November 9, 2016

Re: Pescadito Environmental Resource Center - Webb County
Municipal Solid Waste (MSW) Permit Application No. 2374
Technically Complete Permit Application Supplement Number 3
Tracking Nos. 20877533 and 20683791; CN603835489/RN106119639

CB&I Environmental and Infrastructure, Inc. (CB&I) is providing the attached information to supplement the referenced permit application which was declared technically complete on March 11, 2016. We are providing these changes based on your e-mail request dated October 11, 2016 and in an effort to make the application abundantly clear on the issues. As requested in your e-mail, each specific item of concern is cited below followed by our response:

LIQUID SOLIDIFICATION BASIN PLAN AND DETAILS

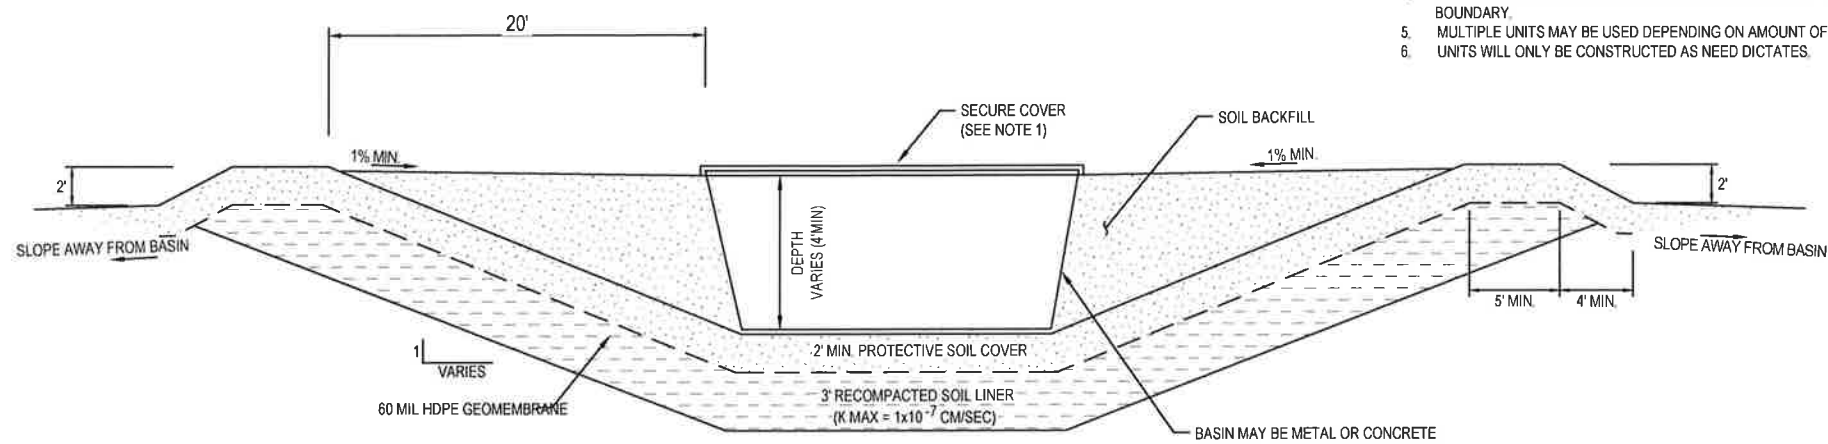
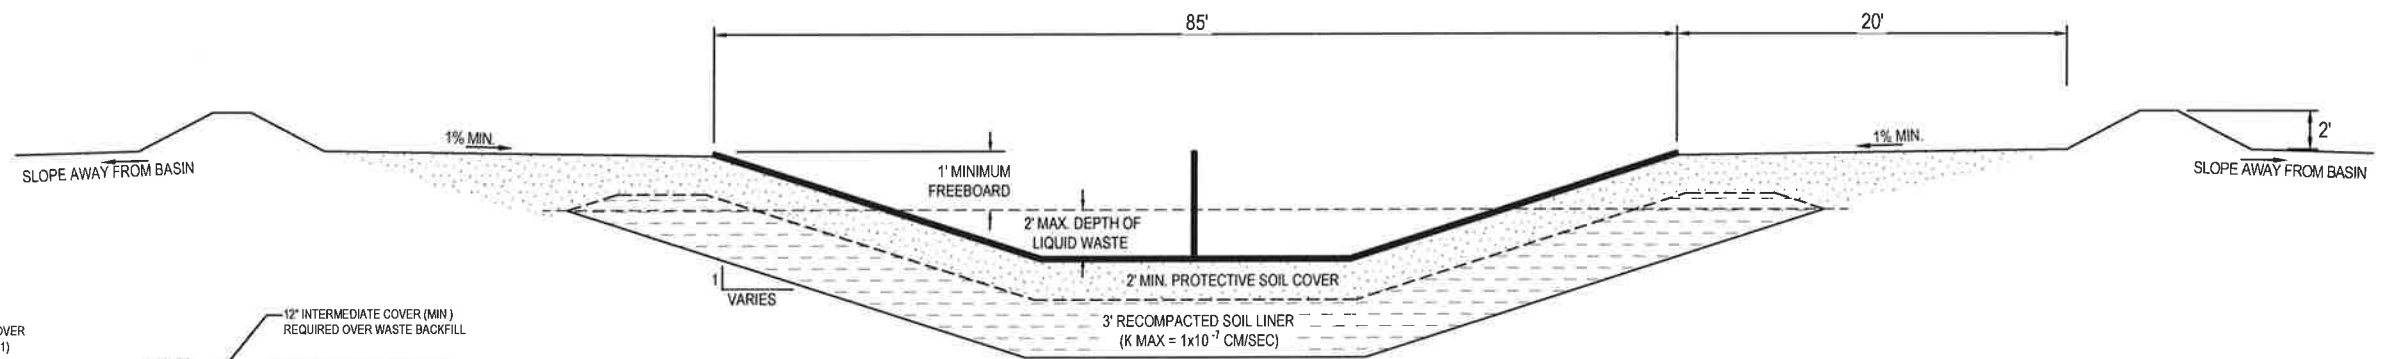
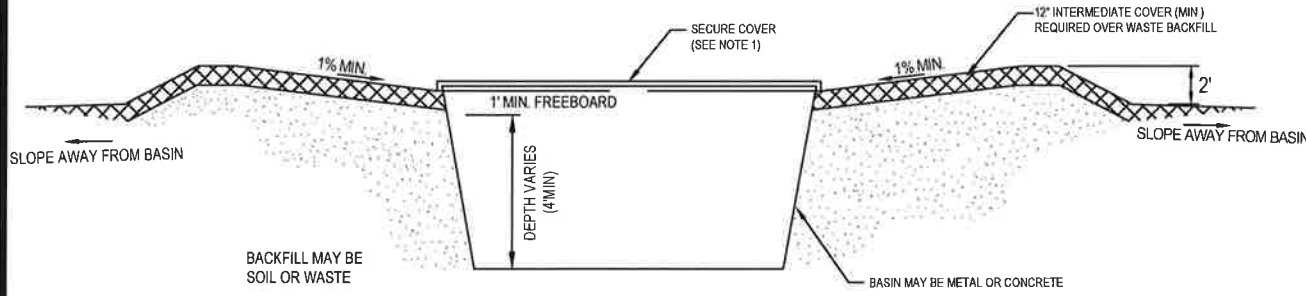
Figure III-B.1-5, Liquid Solidification Basin Plan and Details has been modified to more clearly reflect the drainage around the units. A modified Cover Page, Table of Contents and Figure III.B.1-5 are provided for Part III, Appendix III-B.1.

REV. NO.	DATE	DESCRIPTION
3	11/2016	REVISED SLOPES AT BASINS
2	10/2016	REVISED LIQUID SOLIDIFICATION BASIN DETAILS
1	9/2015	NOD 1

PROJ. NO.: 148866	DATE: APRIL 2015
DESIGNED BY: -	DRAWING NO. III
DRAWN BY: MTE	C.2-3
CHECKED BY: RDS	3 OF 19 SHEETS
APPROVED BY: MWO

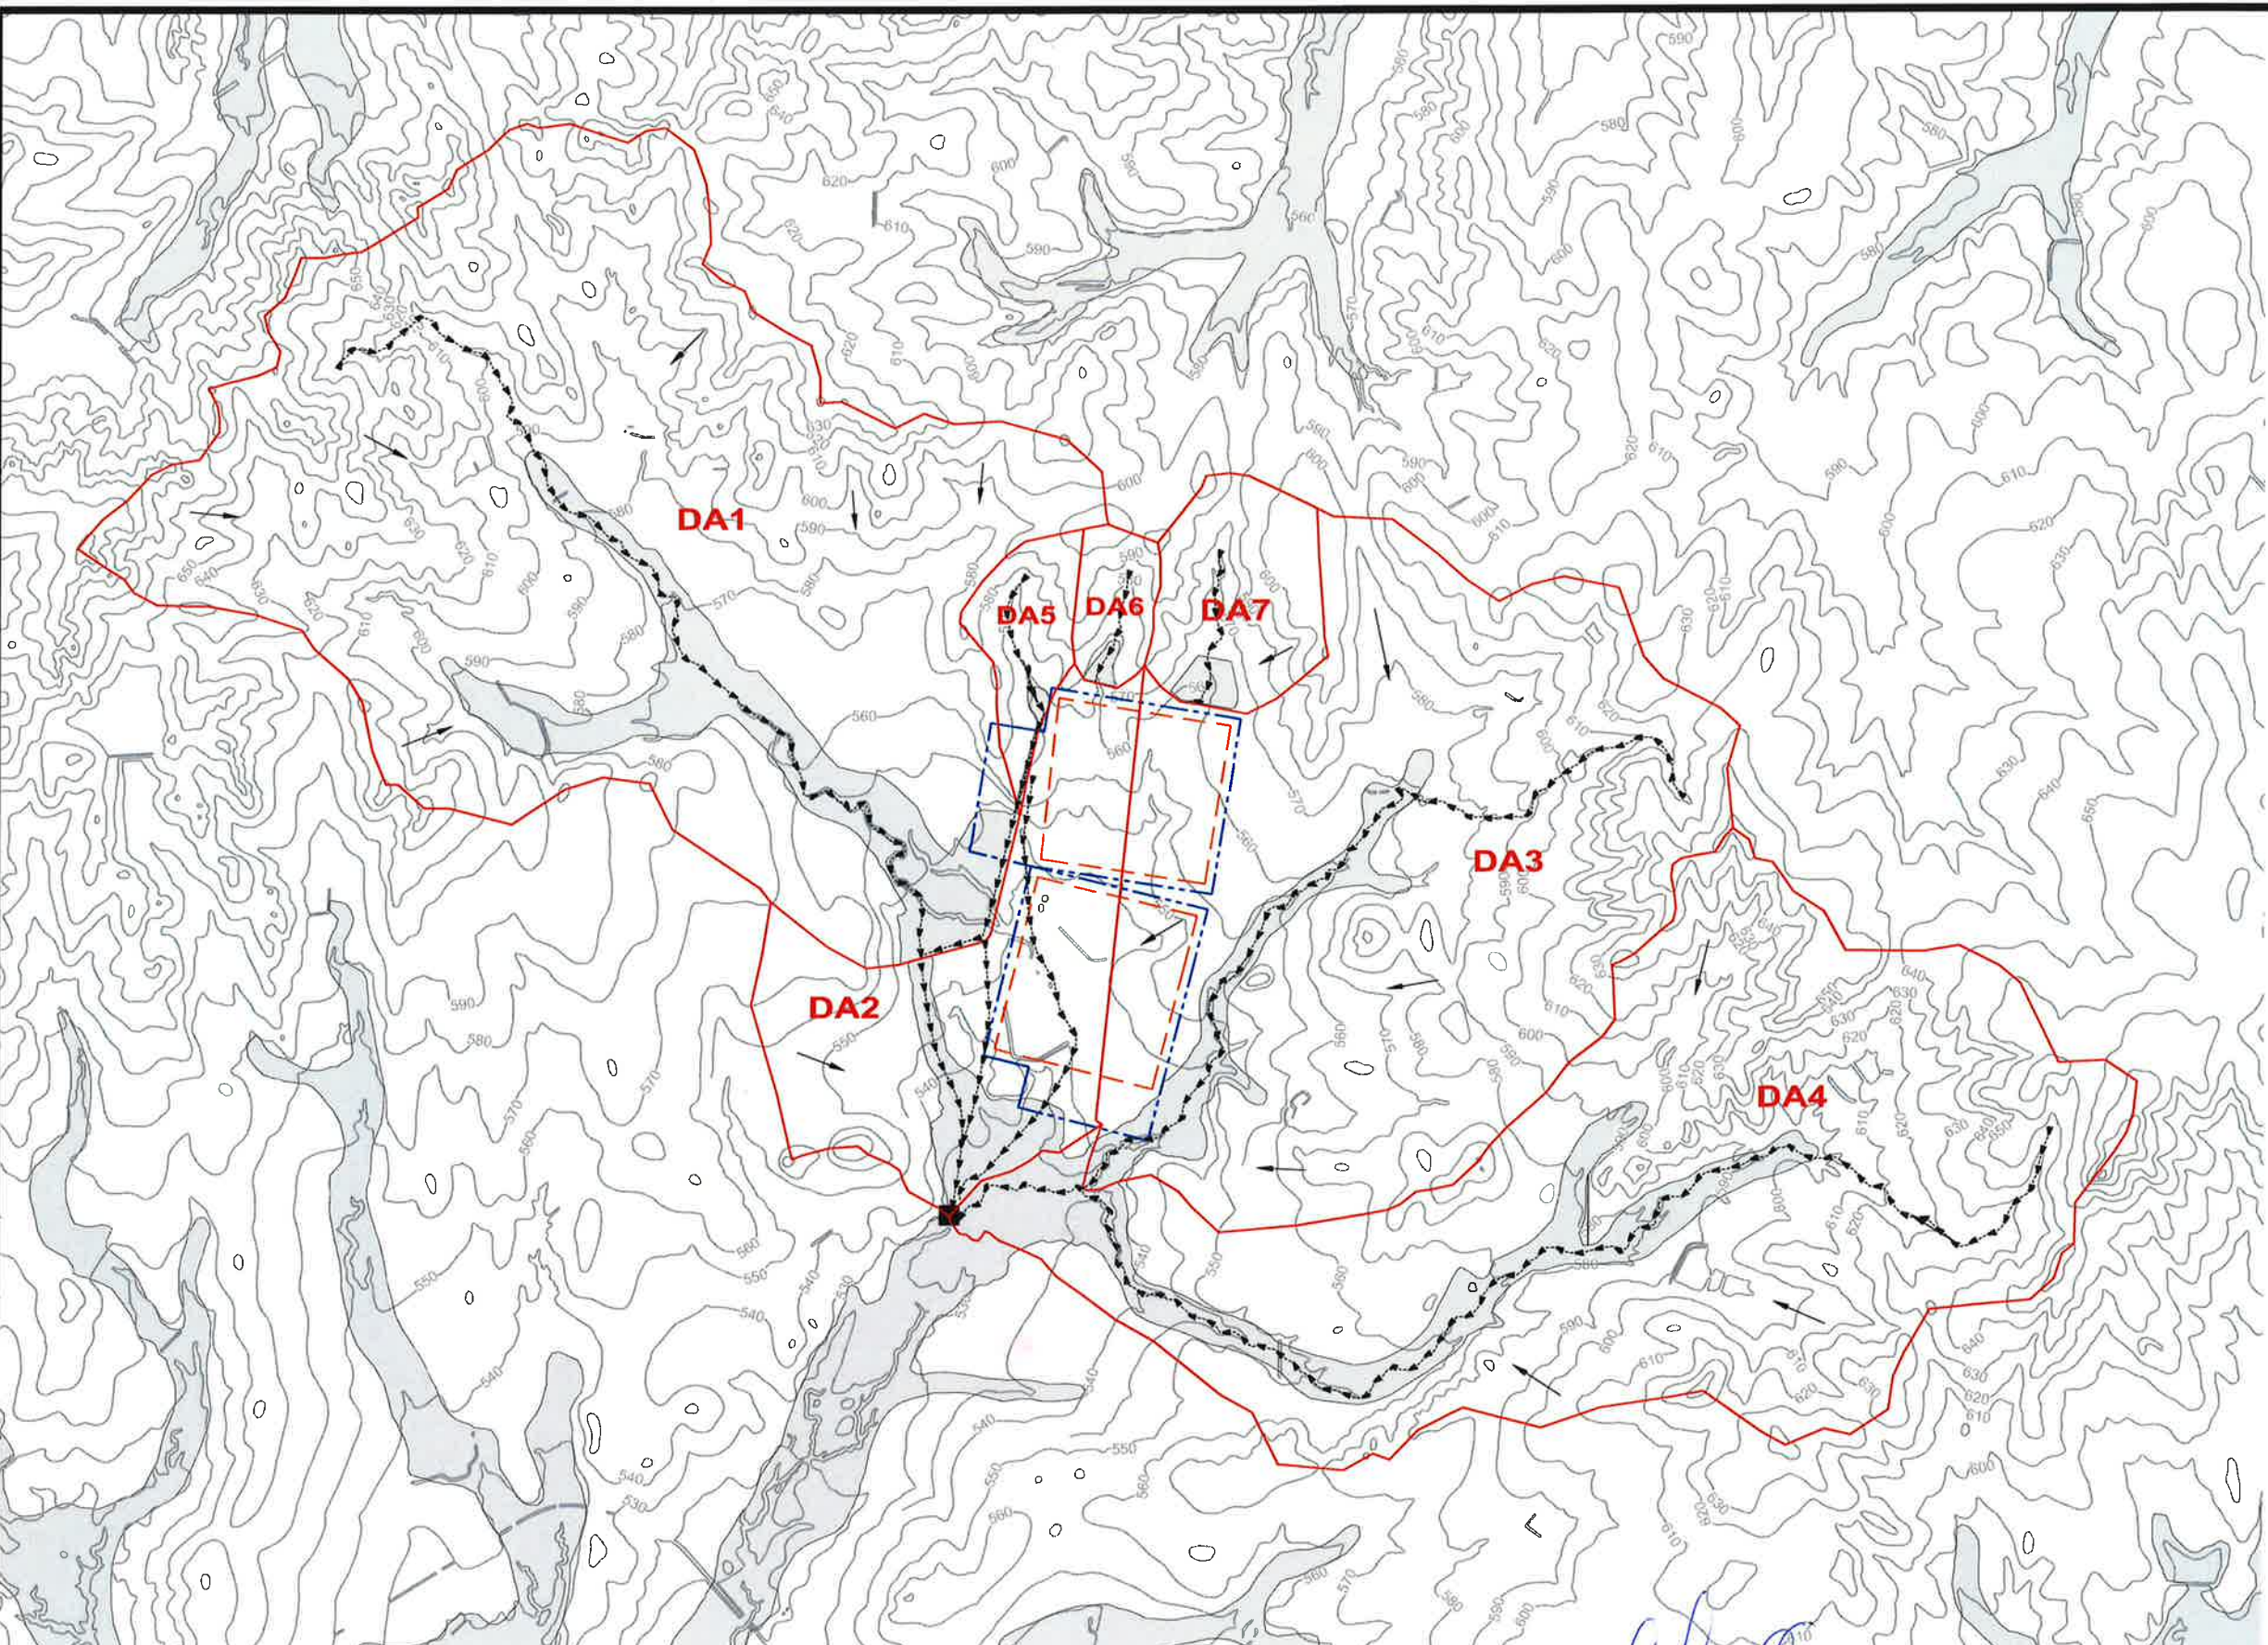
4. The surface water drainage report should be revised to demonstrate that the proposed facility will not adversely alter the existing drainage patterns of the watershed that will be affected in accordance with 30 TAC §330.305(a). The design storm for this demonstration is the 25-year, 24-hour storm. TCEQ Regulatory Guideline RG-417 provides guidance on preparing this demonstration. It is requested that your response to this comment address the procedures presented in RG-417.

Additionally, Figures III.C-2.3, 4 and 5 have been modified to more accurately depict modeled conditions and new Figures III.C-2.18 and 19 have been included as illustration. A modified Cover Page, Table of Contents are also provided for Part III, Appendix III-C.2

1
C.2-11
TYPICAL DETENTION BASIN CULVERT PASSAGE - PLAN VIEW
(SBWIC, SBWIC2, SBEIC)
NOT TO SCALE

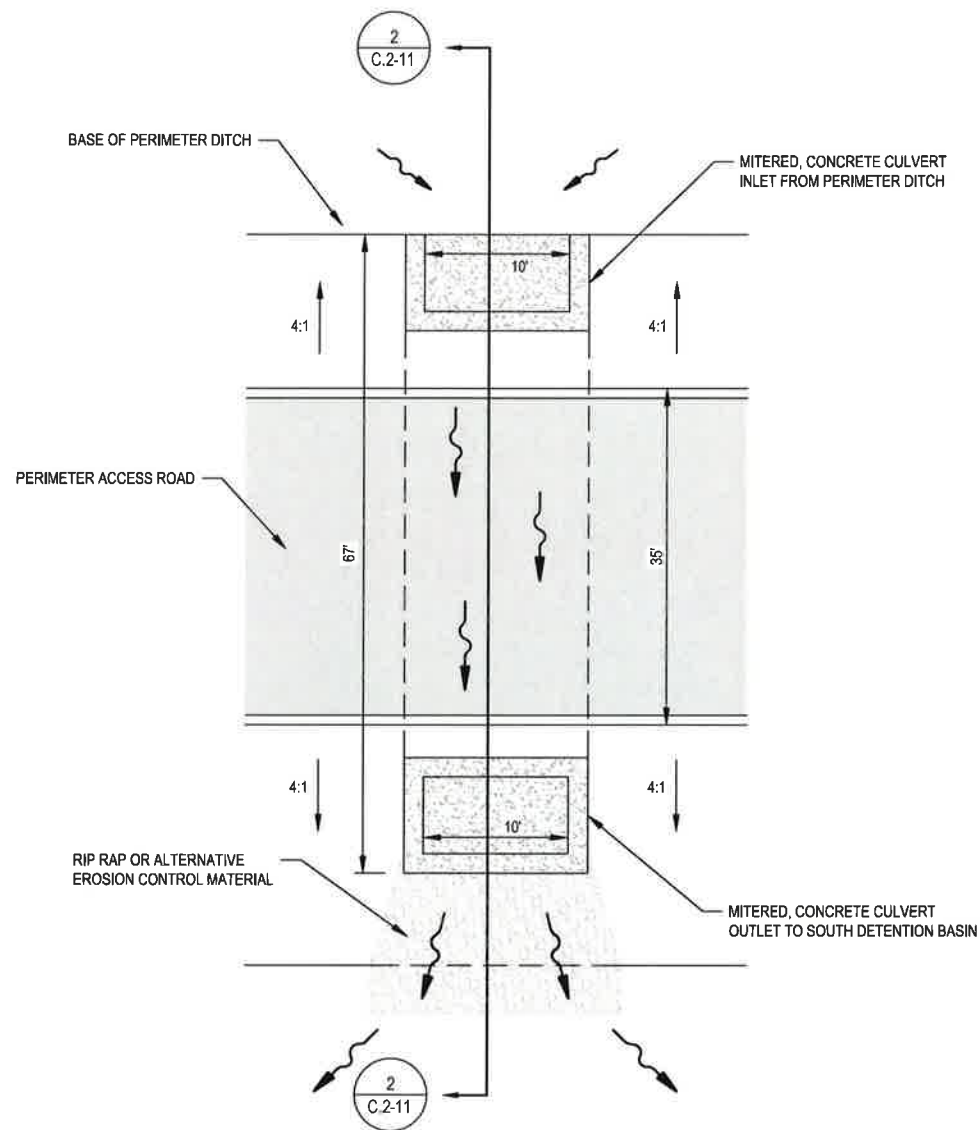
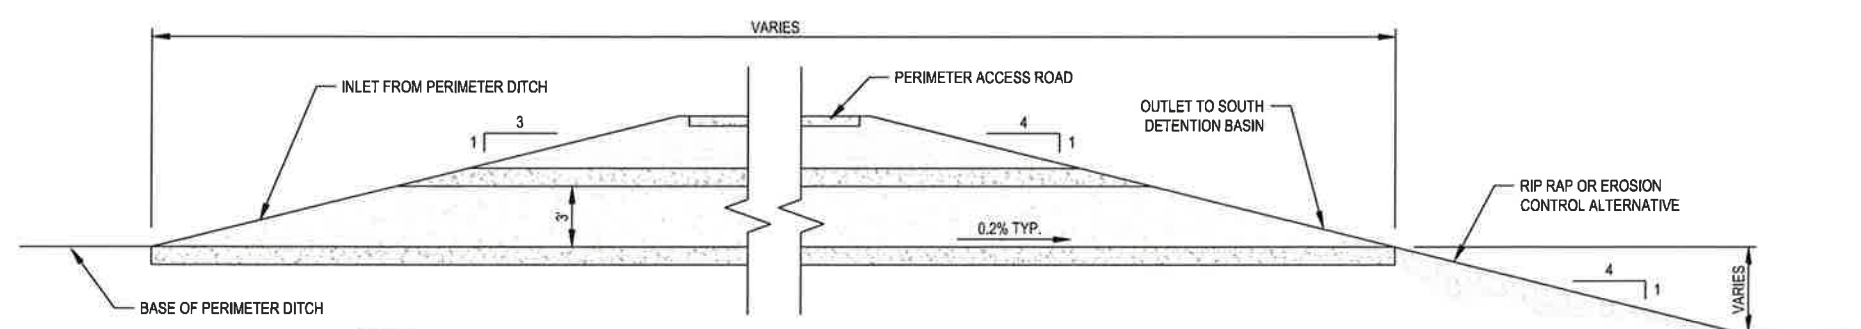
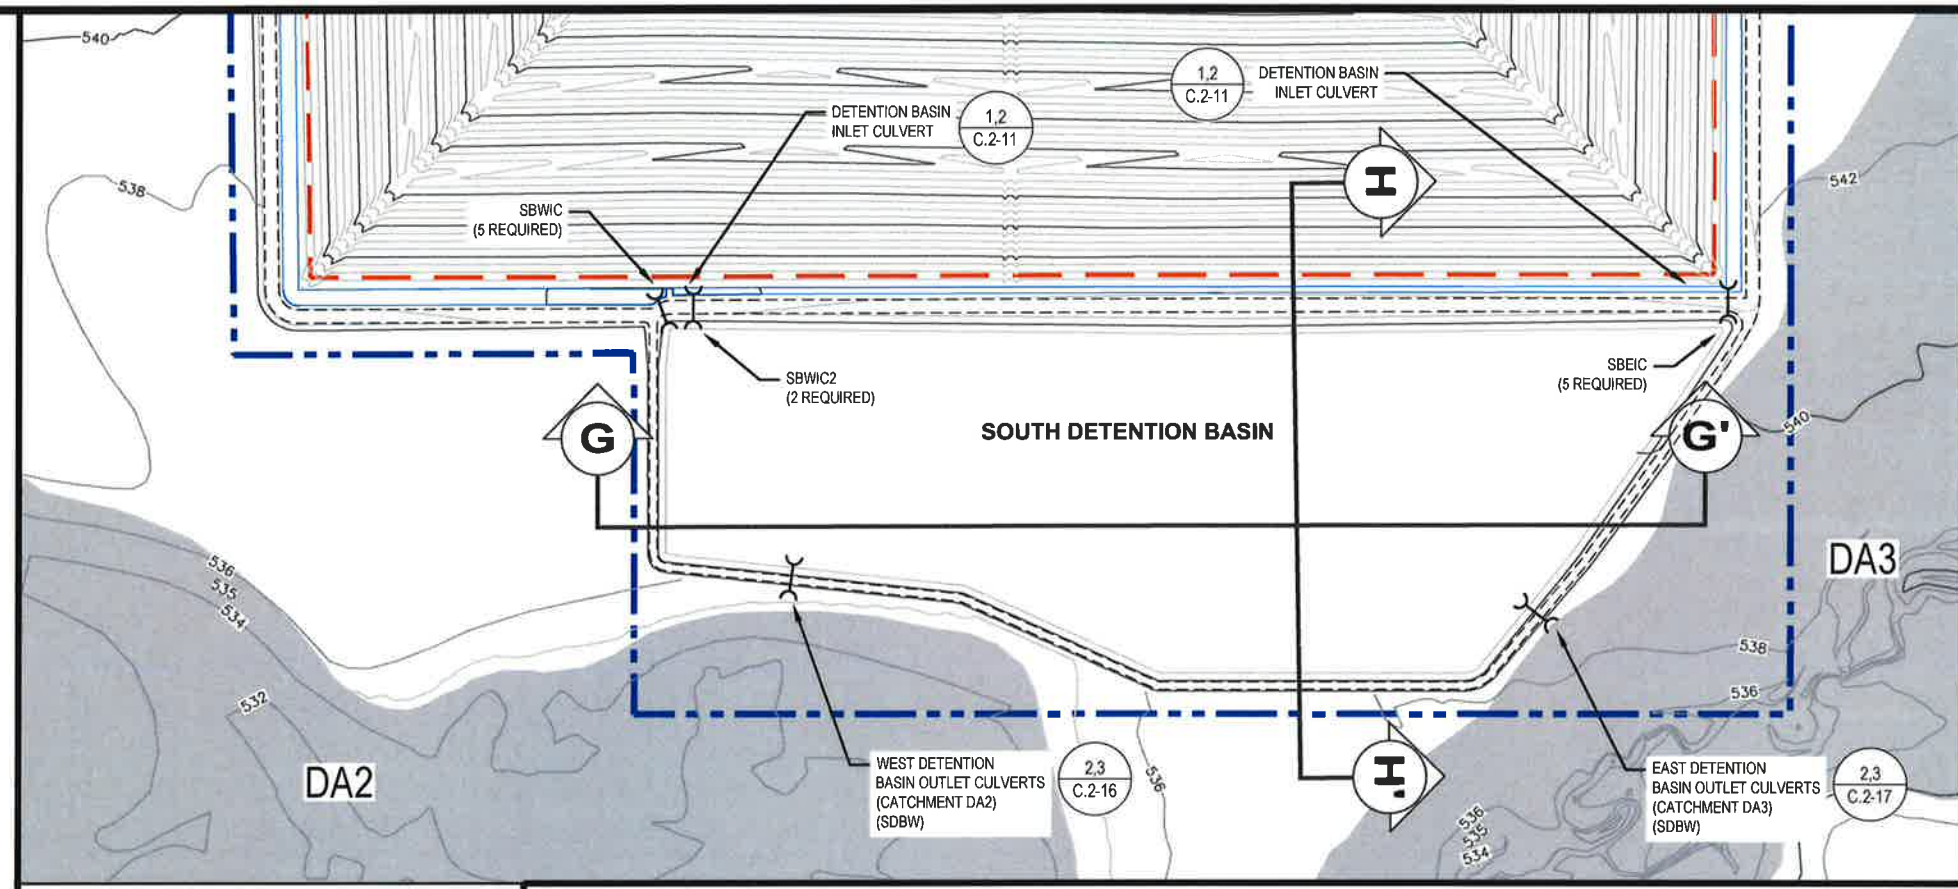
5. The profile drawings of the proposed detention pond indicate that the detention pond will be excavated several feet below natural grade. It is our understanding that the pond is intended to completely drain and not retain any significant amount of collected runoff. Please provide a detail drawing of each discharge structure that depicts how the below grade portion of the pond will be drained by the proposed box culverts. If conveyance structures outside of the permit boundary will be required for the stormwater to be delivered to the natural drainage ways, please provide a discussion and drawing(s) to document these structures. Please provide an easement or similar instrument that will allow for inspection and maintenance of stormwater conveyance structures constructed outside of the permit boundary.

Modified drawings III.C.11 and 12 are provided to better illustrate the drainage from the South Detention Basin. The culverts from the basin discharge into the floodplain on the permitted property and no easements are required.. New Figures III-C.2-16 and 17 are provided for additional detail. A modified Cover Page and Table of Contents, along with the figures listed above, are provided for Part III, Appendix III-C.2.
